1963 - 1965 Corvette: Service Bulletin: Drive Line Noise

Source: Chevrolet Technical Service Bulletin

Bulletin No: #1069

Date: January 7, 1965

FIGURE 1

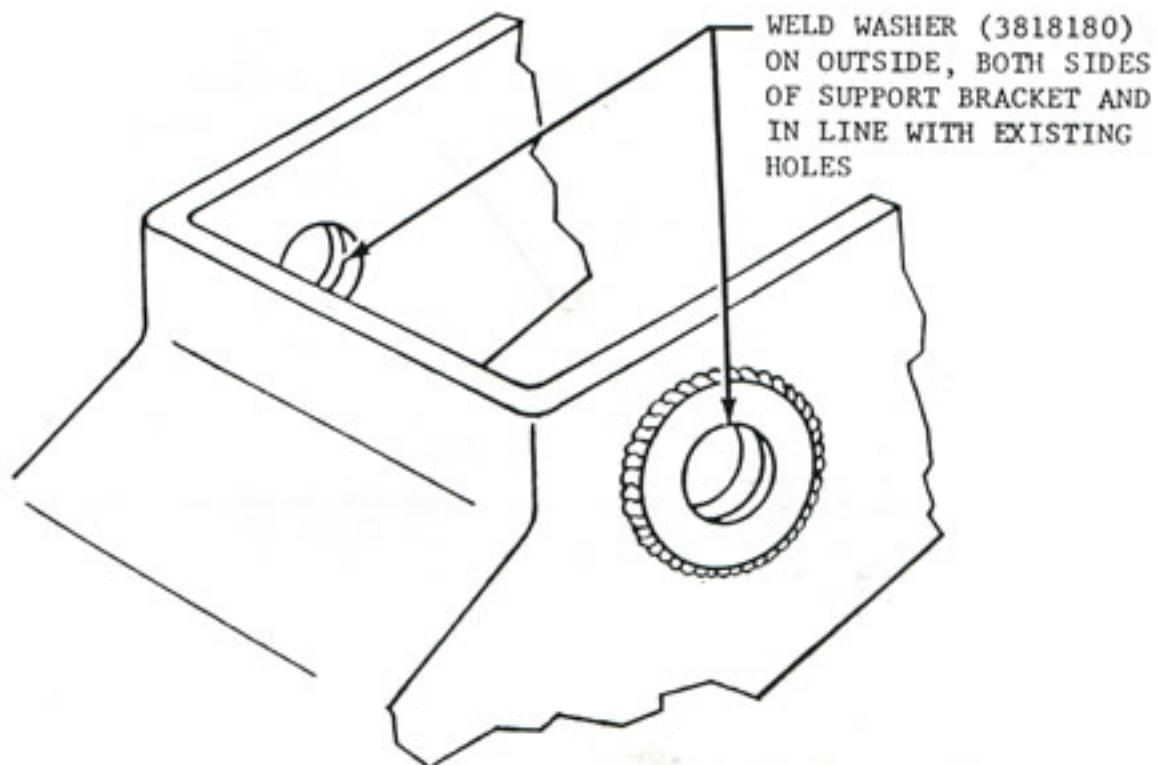
PART I - Re-work of Bracket Part No. 3820186

1. If reinforced bracket, Part No. 3868799 is not available, obtain Part No 3820186 and weld one flat washer, (Part No. 3818180) on each outside surface in line with existing holes (See Figure 1.)

FIGURE 2

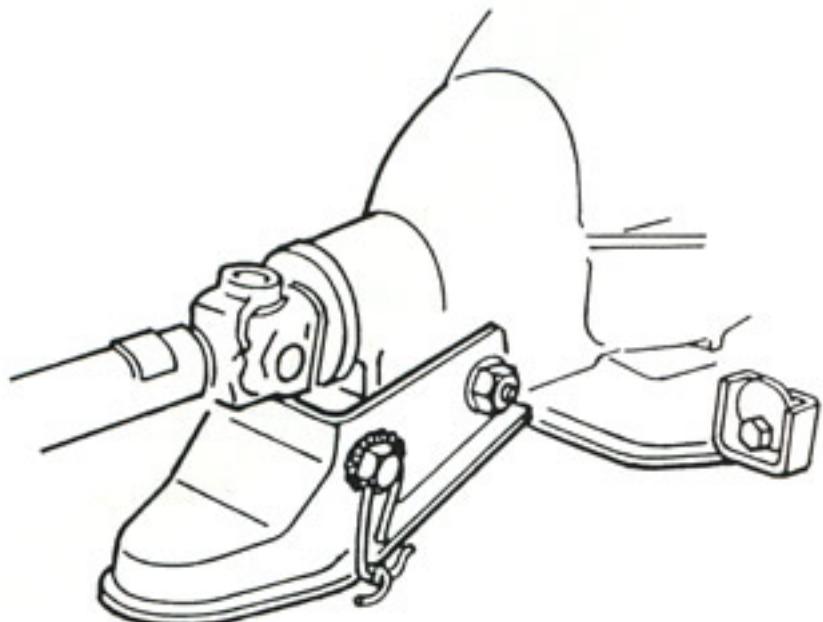
PART II - Safety Wire Procedure

1. Obtain (2) 7/16-14 x 1 300M bolts and drill a 3/32 inch diameter hole through the head of each.
2. Drill a 3/32 inch diameter hole through the lower flange of the carrier bracket directly below the forward bolt hole (both sides of bracket).

3. Install new bracket using modified forward attaching bolts. Torque forward attaching bolts to 65 ft. lbs.
4. Safety wire the forward bracket bolts to the bracket with stainless steel safety wire (1/16 inch O.D.) or stainless steel welding rod (1/16 inch O.D.).

NOTE: Be sure the straight wire from the bolt head to the flange hole is on the tightening side of the bolt. (See Figure 2).
5. Tighten the wire sufficiently by twisting the ends together. NOTE: Over-tightening will cut the wire at sharp bends.
